Change Order #10

Regional Linear Park Phase II (Hike & Bike Trail)

Project: Regional Linear Park Phase II
Project#: STP 2019 (086) TP
Contract: C-18-199-02-12
CSJ: 0921-02-409
Limits: Hall Acres to Ridge Road

CONSTRUCTION CONTRACT CHANGE ORDER NUMBER: 10

67a

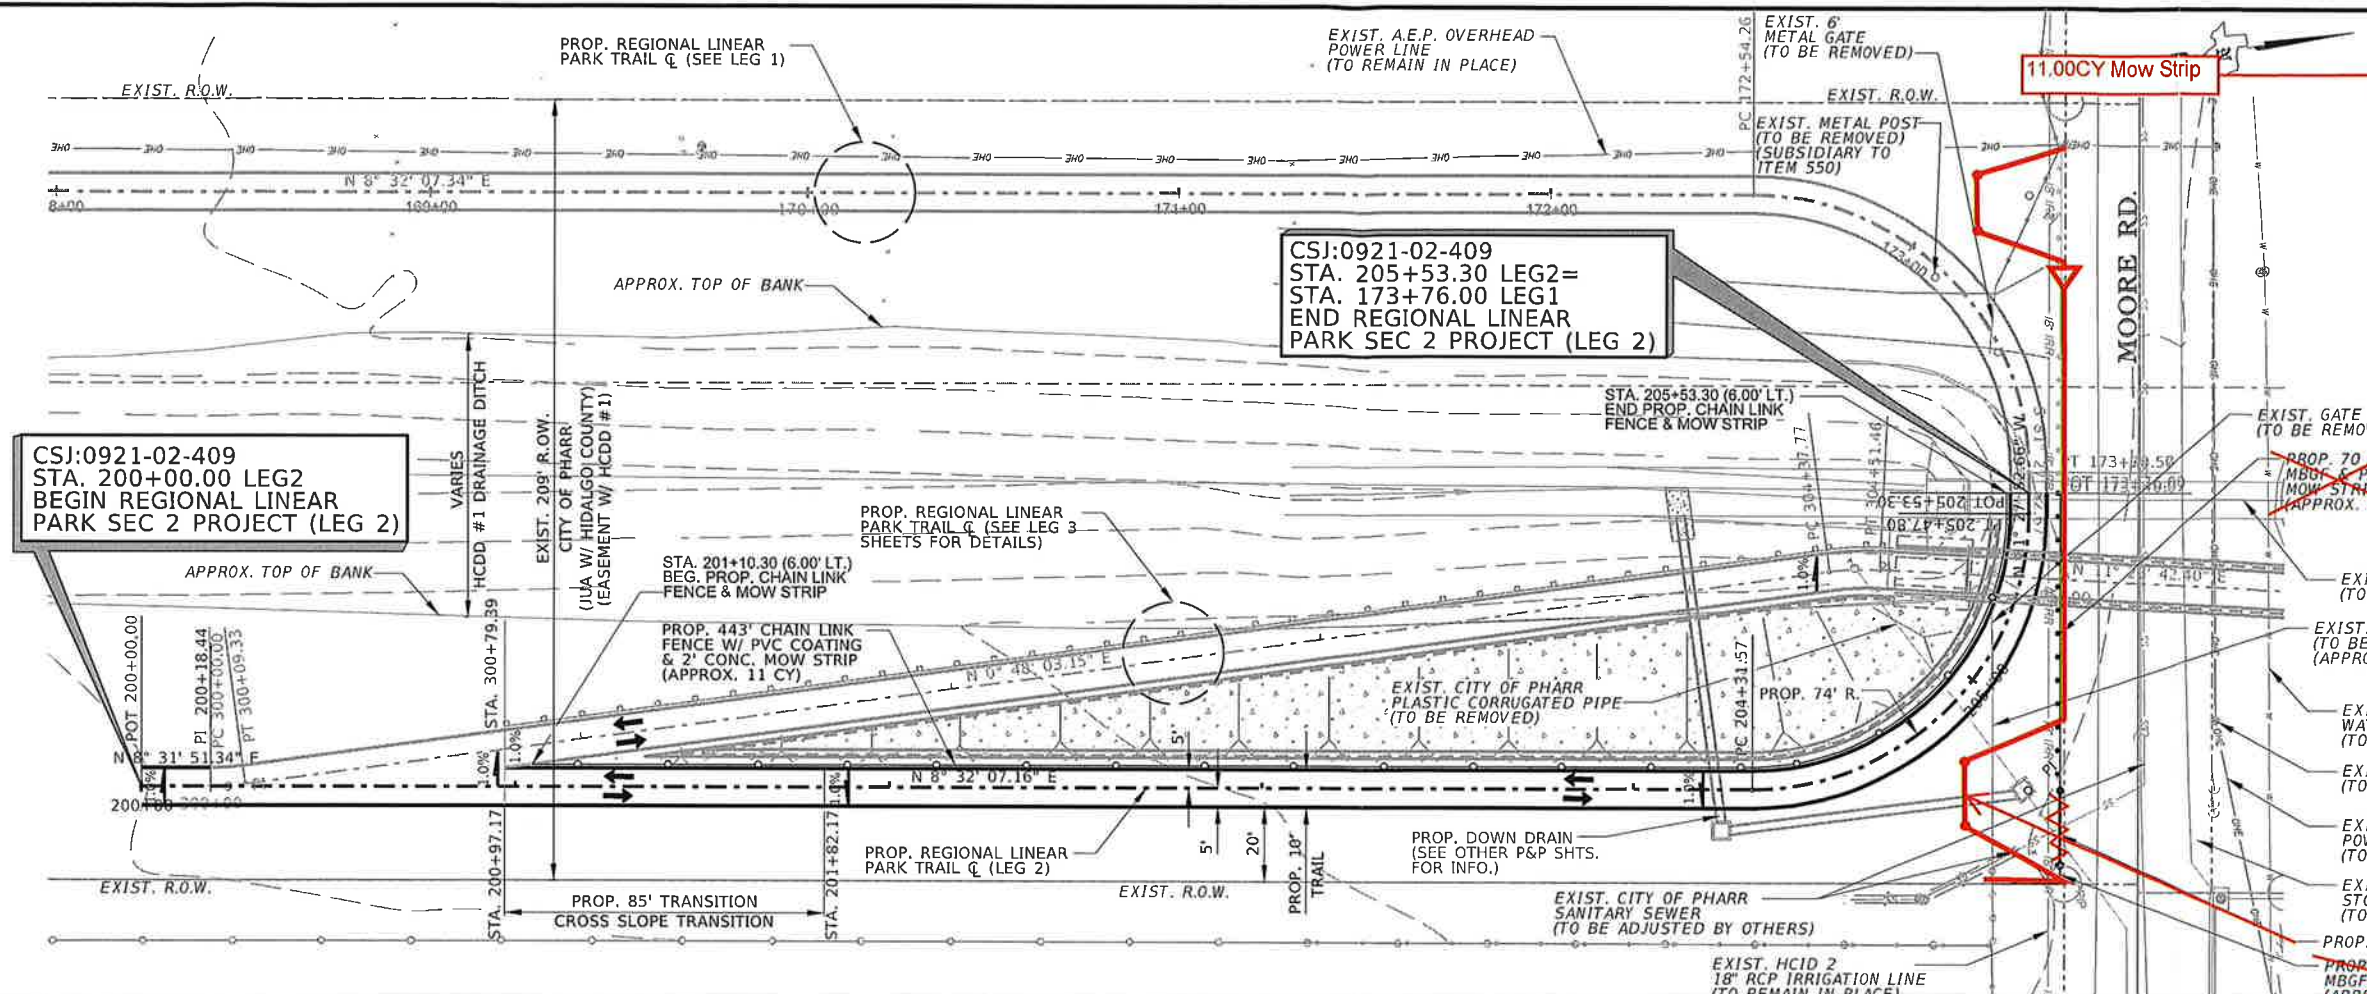
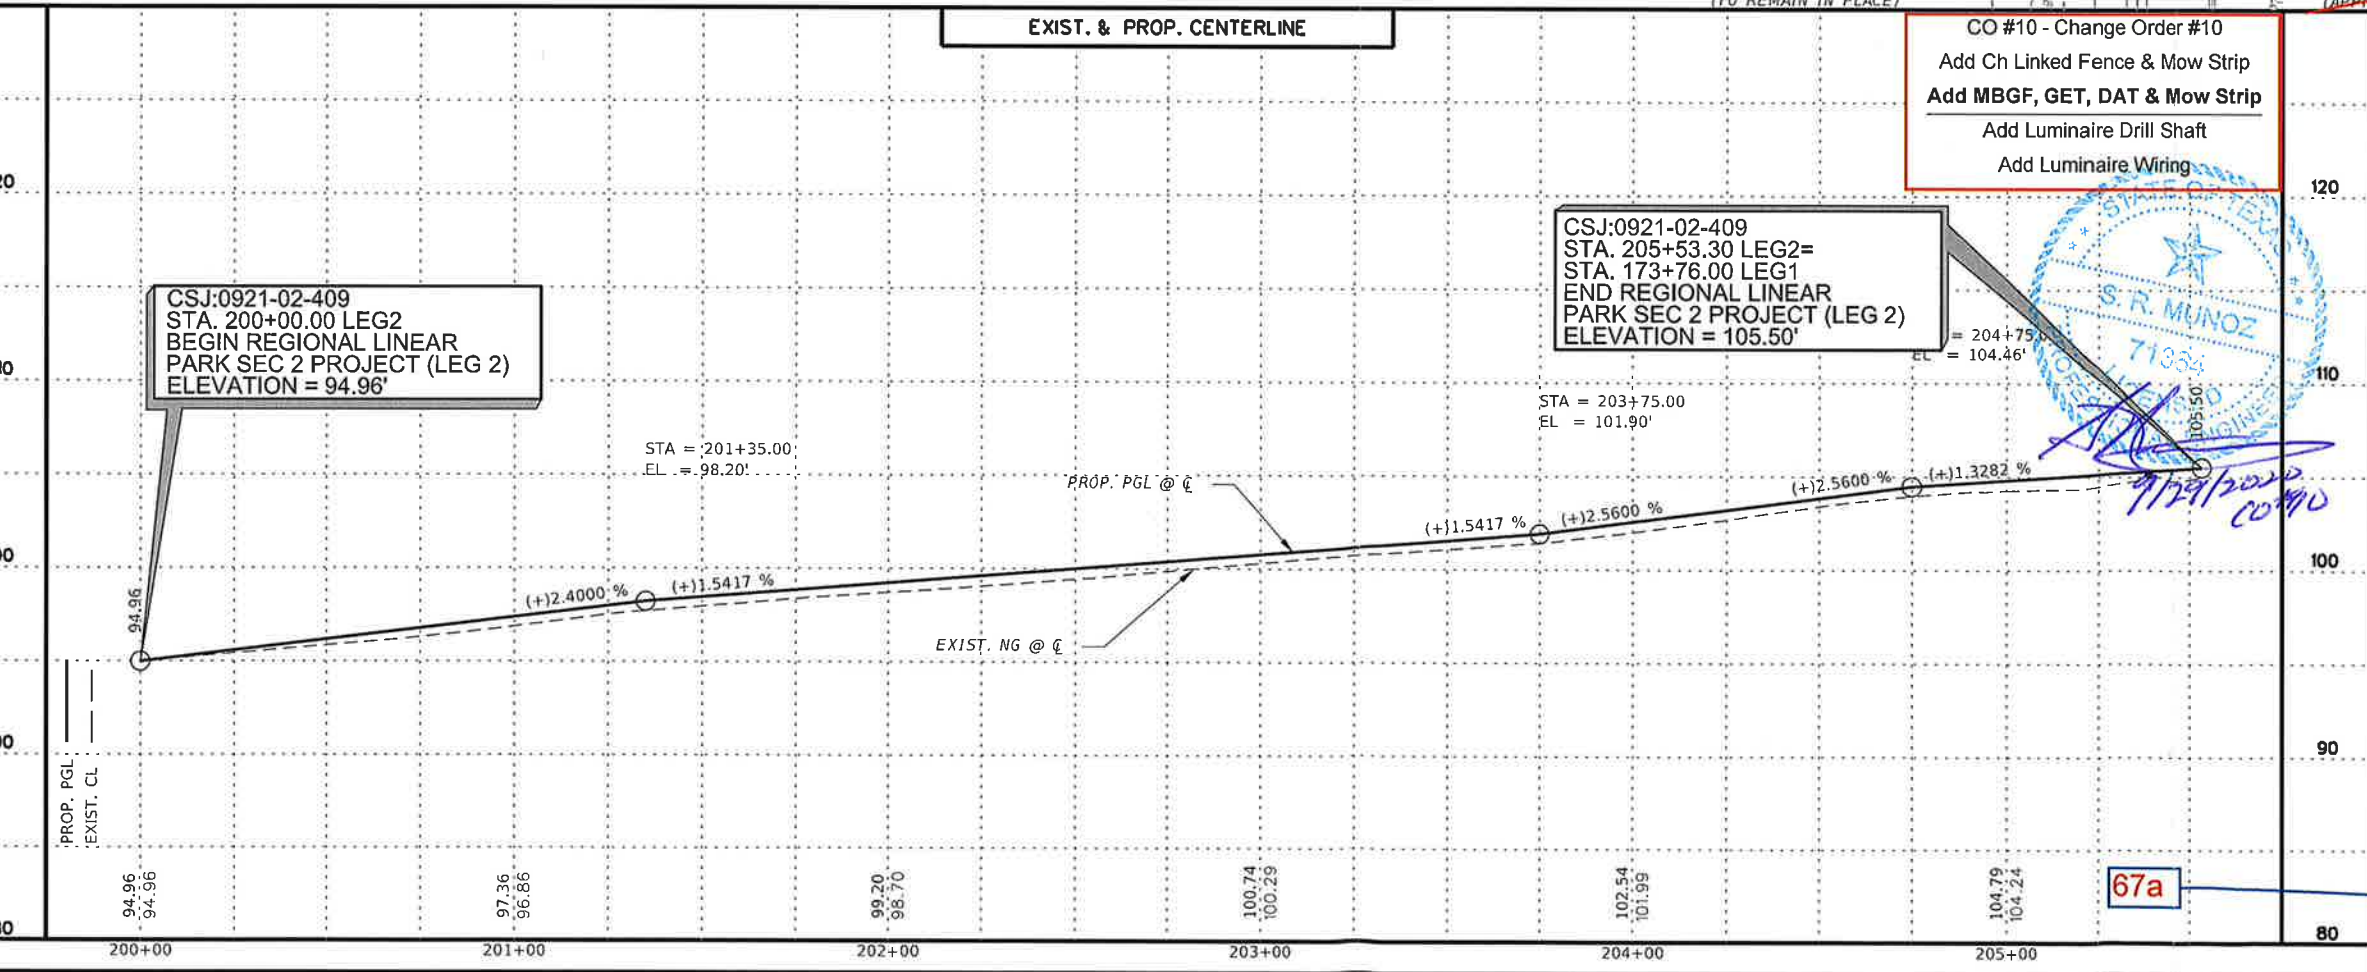
SHEET SUMMARY			
ITEM	DESCRIPTION	UNIT	QUANTITY
432	REMOVE CONC (14") (MOW STRIP)	CY	14
540	INSTALL STR MBGF	LF	70
542	REMOVE STR MBGF	LF	70
550	GATE (INSTALL) DOUBLE (18'x16')	EA	1
550	CHAIN LINK FENCE (INSTALL) (6')	LF	443
550	GATE (REMOVE)	EA	1

125a

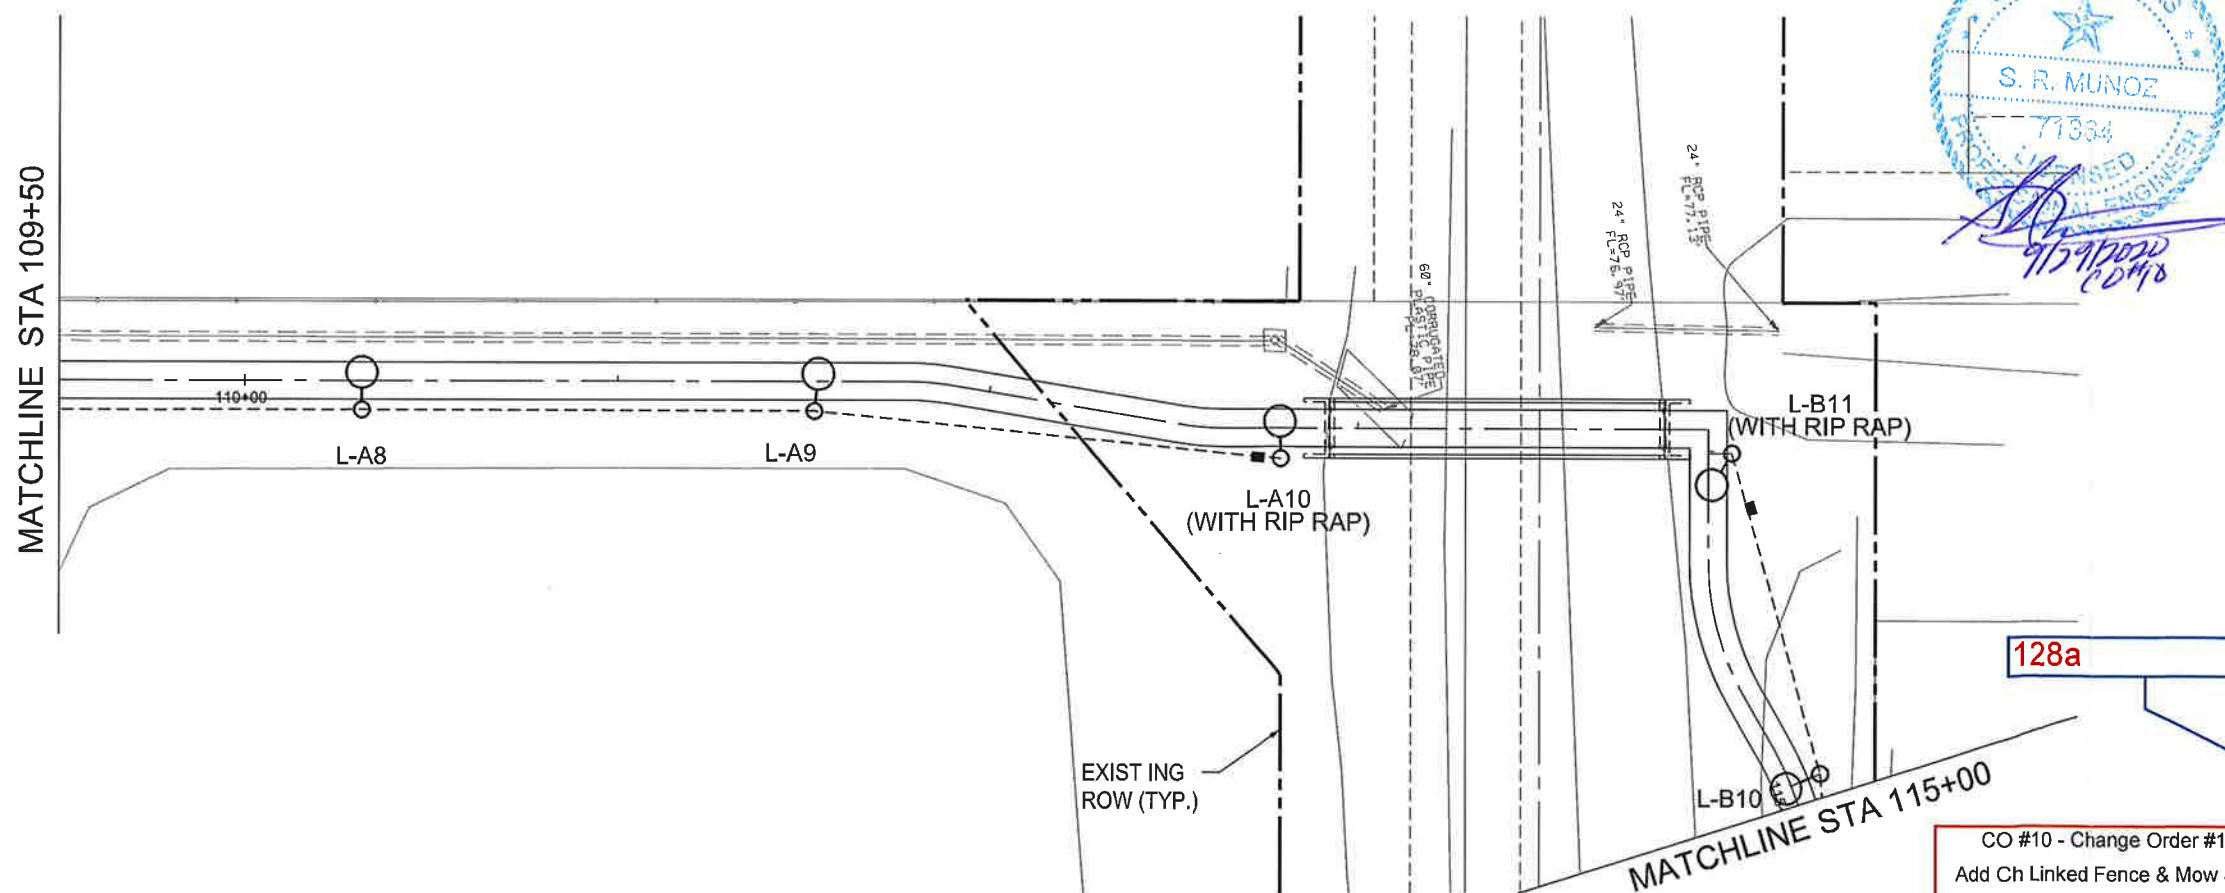
CO #3
Plans did not account for existing utility easement adjacent to the hike and bike trail. In order to place conduit, wiring, poles and luminaires outside of the easement, the alignment will cross to the inside of the trail. Plan sheets were originally prepared by consultant L&G and modified by B2Z engineering. Modified to show new alignment. An additional expense to pay for conduit, only, placed on the wrong side before modifying the alignment.

CO #10

131a

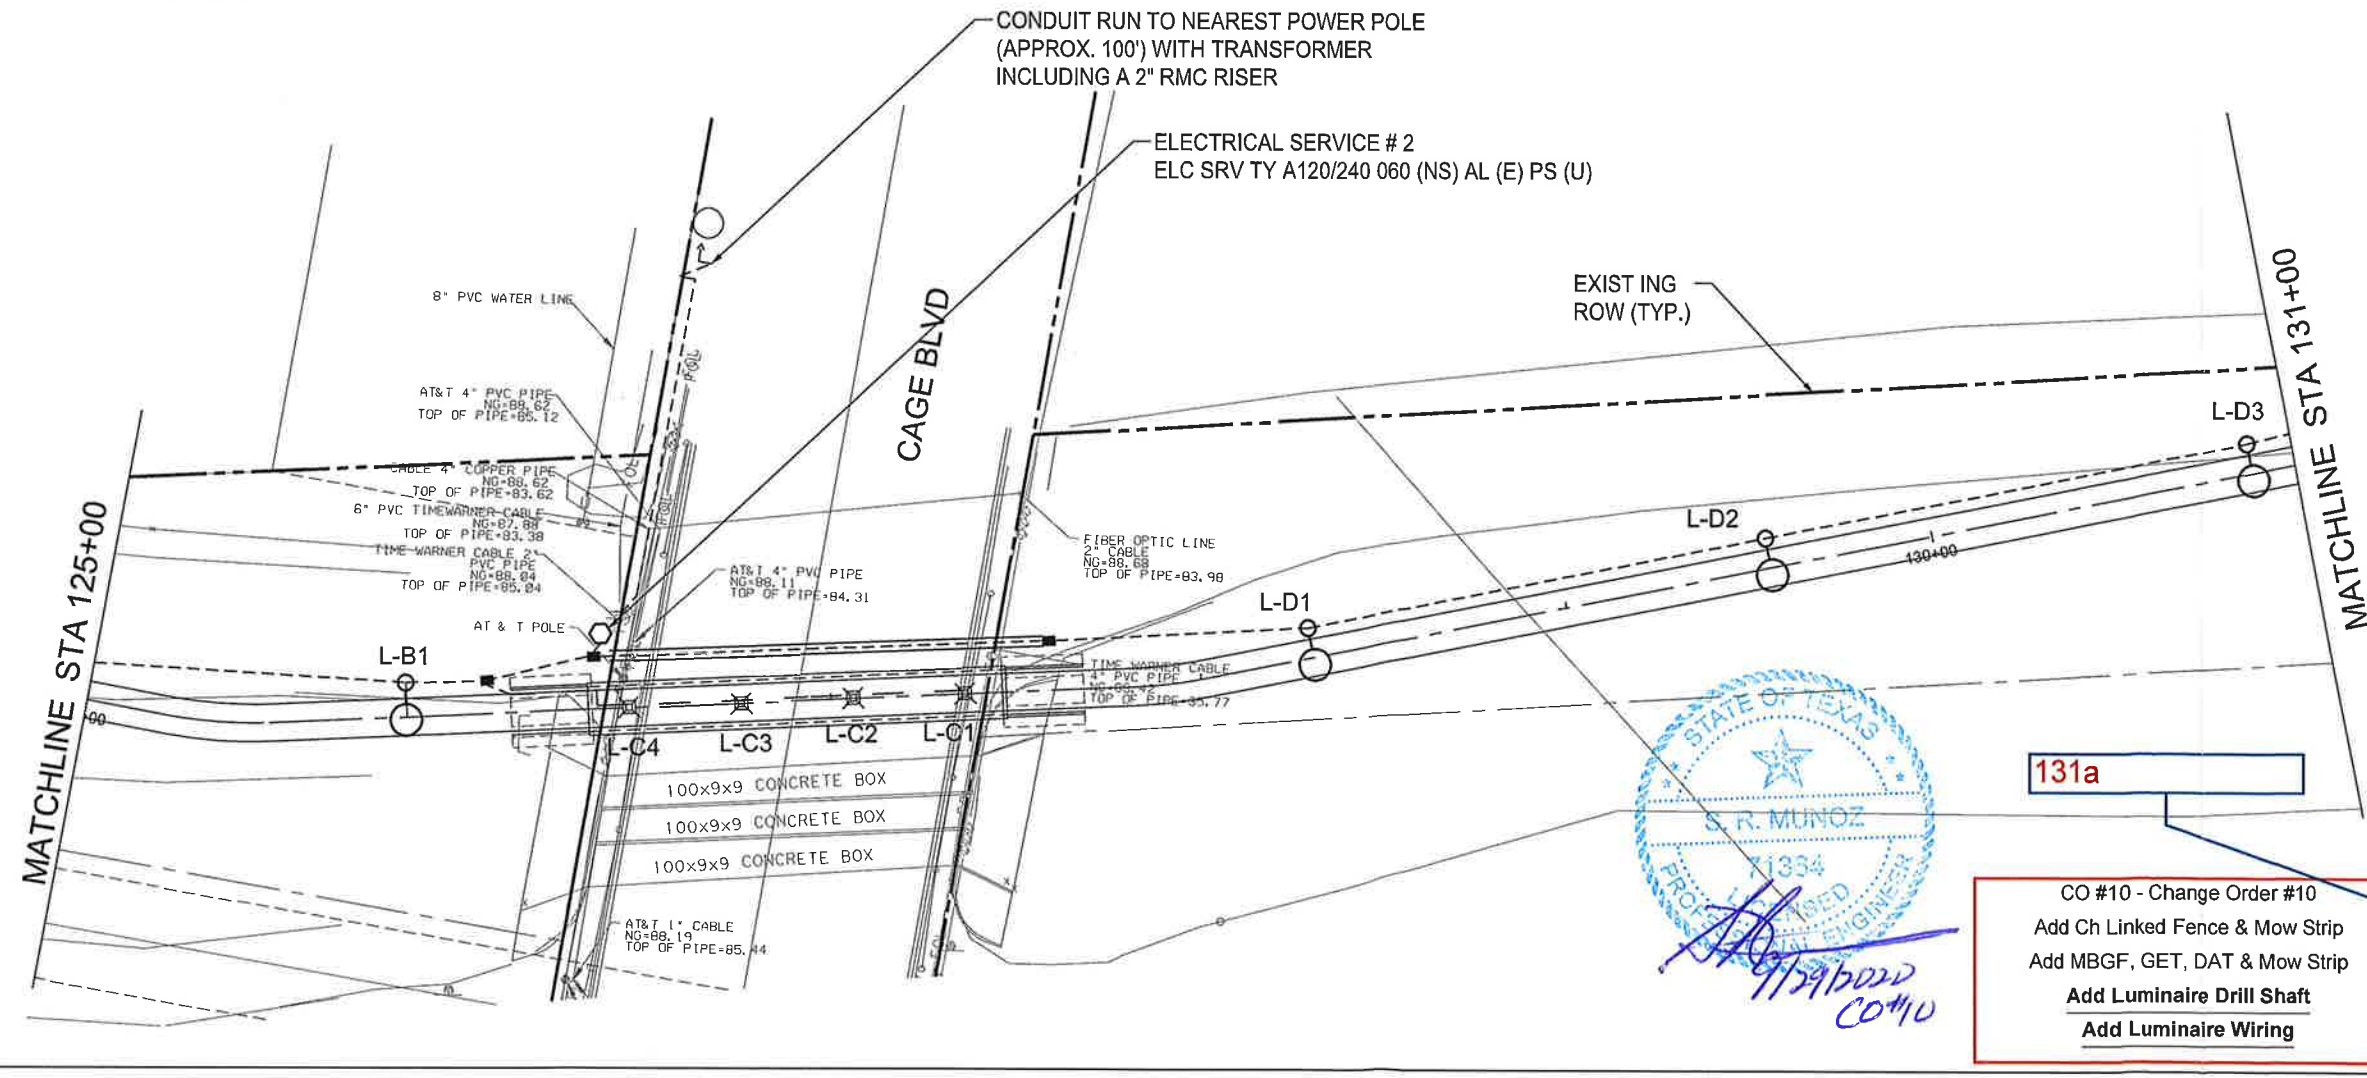
9/29/2022
 CO #10

ILLUMINATION QUANTITIES - SHEET TOTALS				
ITEM	DESCR CODE	DESCRIPTION	UNIT	QUANTITIES
				SHEET 14
416	6029	DRILL SHAFT (RDWY ILL POLE) (30 IN)	LF	72 CO #10
HC 001		FURNISH AND INSTALL LIGHTING FIXTURE (LED WATERPROOF) TYPE ILX3525-055UV-F5M-55ND-SSL (IP68) WITH AN IP68 GLAND, IP68 JUNCTION BOX AND STEEL WIRE MESH COVER ASSEMBLY PROTECTION	EA	4
610	6500	IN RD ILL (TY SA) 30S-4 (400W EQ) LED WITH TRASTAR DURALIGHT DURA-ST40-4K-120-2-GR-SCLB [1]	EA	7
610	6500	IN RD ILL (TY SA) 30S-4 (400W EQ) LED WITH TRASTAR DURALIGHT DURA-ST40-4K-120-2-GR-SCLB		2
618	6023	CONDT (PVC) (SCH 40) (2")	LF	1395 CO #10
620	6007	ELEC CONDR (NO.8) BARE	LF	1490 CO #10
621	6007	TRAY CABLE (4 CONDR) (8 AWG)	LF	1,480
HC 002		ELEC CONDR (NO.10) PVC JACKET, 90 DEGREE CELCIUS INSULATION, 600V	LF	560 CO #10
HC 009		GALVANIZED RIGID STEEL CONDUIT (1-1/4")	LF	130
624	6001	GROUND BOX TY A (122311)	EA	6
